Introduction

This chapter of the FEIR for the Union City Intermodal Station Passenger Rail Project (Proposed Project) contains Master Responses intended to consolidate in one discussion the responses to key issues on a single subject raised in multiple comments. Responses to issues that fall outside of the Master Responses are addressed in the FEIR Chapters 3 and 4. Revisions made to the DEIR pursuant to Master Responses are included in the FEIR Chapter 4. Where an individual response to a comment is covered by a Master Response, this is also noted in the FEIR Chapters 3 and 4.

PD-3: Redesigned Shinn Connection

02279.02 FEIR (1-06)

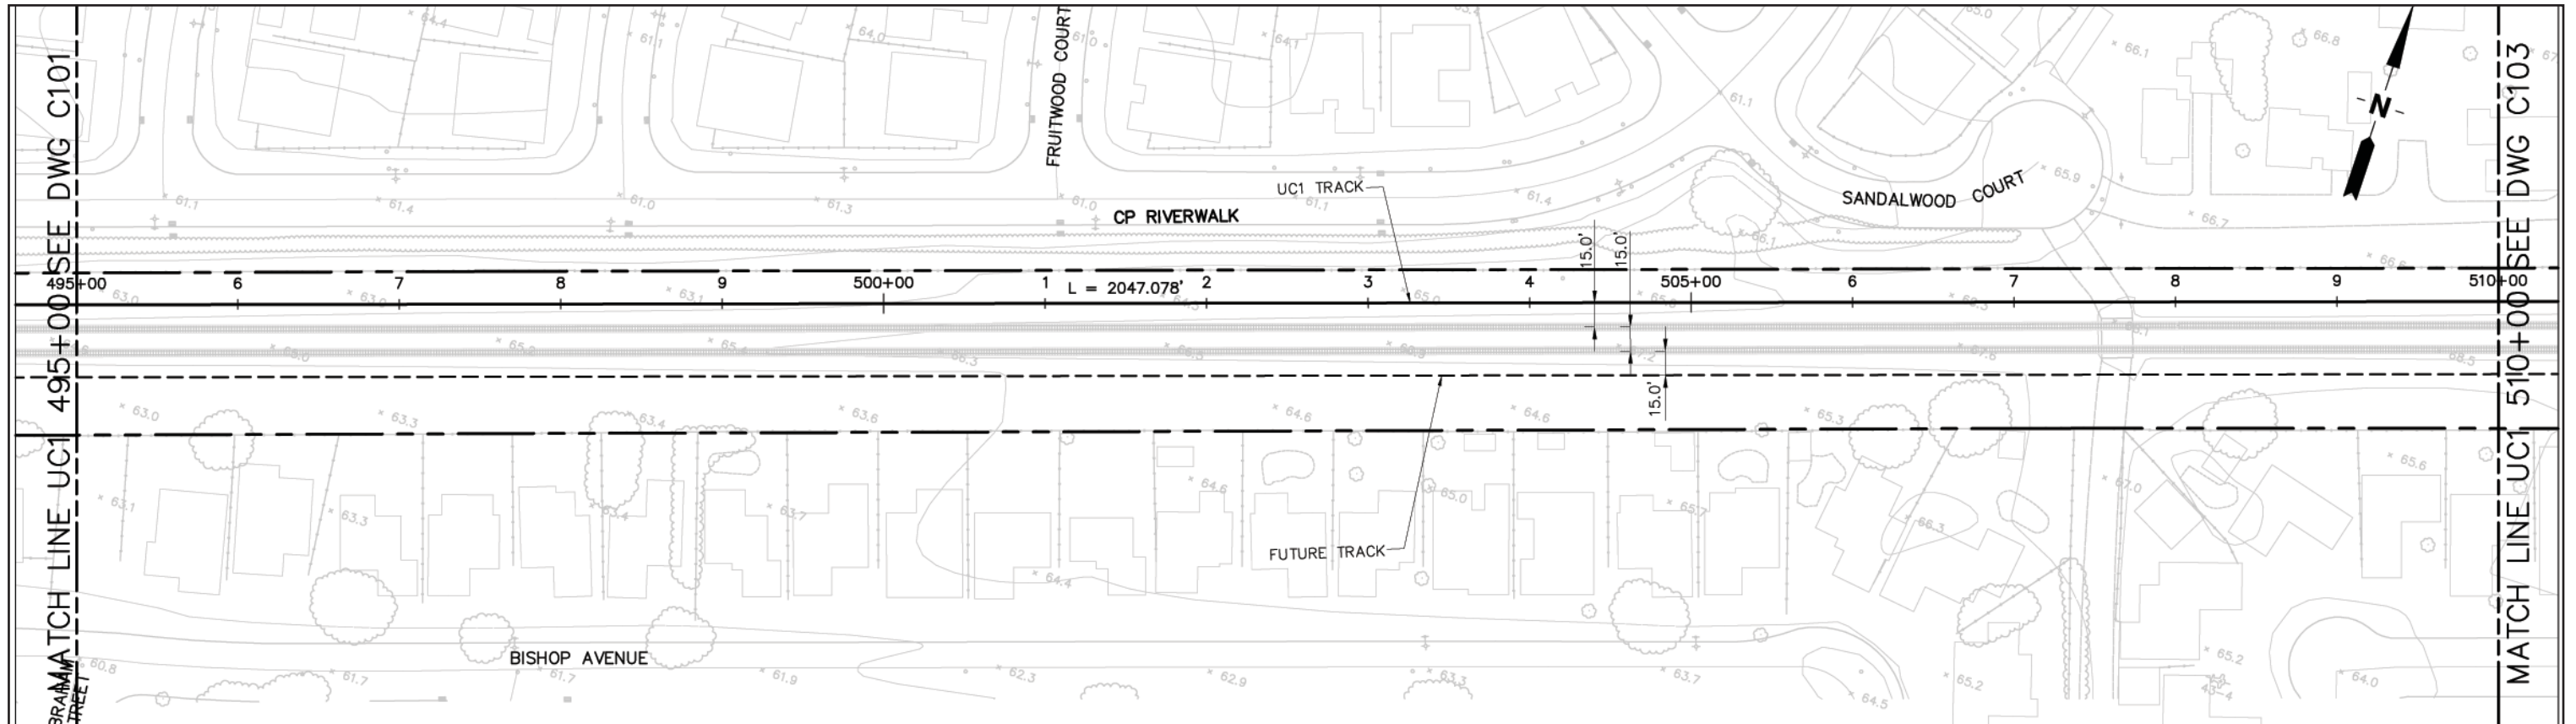
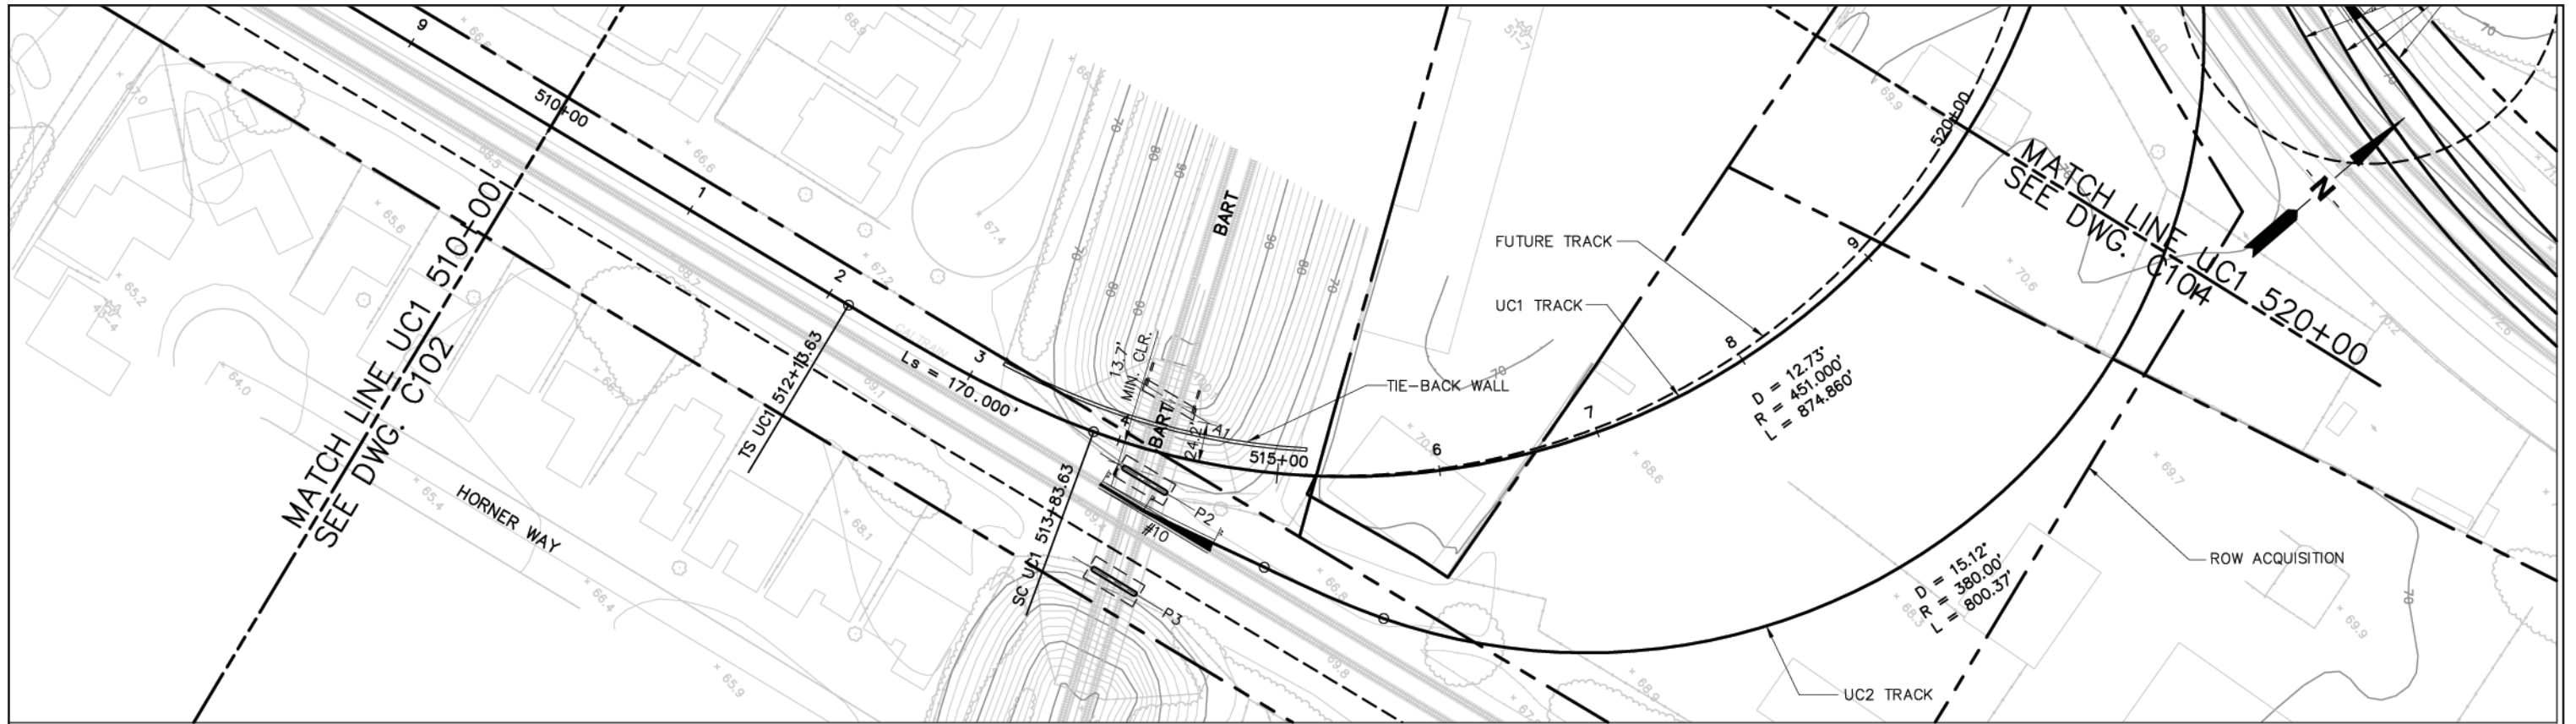
Several comments expressed concern about the effectiveness of movable point or spring rail frogs in mitigating noise and vibration impacts associated with turnouts. Some comments also suggested that the turnout adjacent to the Riverwalk neighborhood be relocated farther to the west, as was suggested as possible mitigation in the DEIR. In response to those comments, the City has revised the project to relocate the turnout adjacent to the Riverwalk neighborhood to the west, past the western end of the neighborhood and to

Several comments on the DEIR expressed concern about the effect of the Shinn connection on the Riverwalk neighborhood. Specifically, the comments addressed the need to acquire property, remove landscaping, and replace the fence at the end of Riverwalk Drive; the aesthetic impacts of the underpass of the BART tracks; air quality, noise, and vibration impacts, and construction noise and lighting. The City has developed a revised design for the Shinn connection that incorporates the recommendations made in comment by individuals and local agencies. The redesigned Shinn connection moves the new section of curved track slightly farther to the east and adds a second set of tracks to improve train movement (see Figures 2-1 through 2-7).

The revised design eliminates the need to acquire property from the Riverwalk neighborhood and moves the new tracks for the Shinn connection farther away from residences. The northern/western tracks join the Centerville Line west of the Riverwalk subdivision and incorporate moveable point frog technology into the design of the turnout where the tracks connect. The southern/eastern set of tracks would connect to the Centerville Line underneath the BART overpass (see Figure 2-5). The connection would incorporate moveable point frog technology for the turnout where the tracks connect. In the DEIR, the Shinn connection joined the Centerville Line adjacent to the Riverwalk subdivision and the moveable point frog was not part of the Proposed Project design, but was recommended as mitigation for noise and vibration impacts. The moveable point frog eliminates noise and vibration impacts associated with the turnout, therefore, DEIR Mitigation Measure NV-3, Relocate Turnouts or Install Spring Rail “Frogs,” is no longer necessary.

The northern tracks pass under the BART tracks farther to the east than the design in the DEIR and slightly farther from the home at the eastern terminus of Riverwalk Drive. This alignment would require considerably less modification of

the BART overpass of the Centerville Line than the design in the DEIR and would not require acquisition of any right of way from the Riverwalk Homeowners Association. Additionally, the existing sound wall and landscaping at the southeastern boundary of the Riverwalk subdivision would not be affected by the revised Shinn connection and would therefore not need to be replaced.

Both sets of tracks in the redesigned Shinn connection would have a tighter curve than the design in the DEIR and would therefore have a higher likelihood of generating noise from wheel squeal. With the redesigned Shinn connection, the BART berm and the existing sound wall on the southeast boundary of the Riverwalk subdivision would shield the neighborhood from wheel squeal and, therefore, DEIR Mitigation Measure NV-1, Replace Existing Sound Wall in the Riverwalk Subdivision along the New Shinn Connection, is no longer required to mitigate noise from wheel squeal. Please see PRDEIR for a detailed discussion of noise impacts and mitigation measures related to the redesigned Shinn connection.
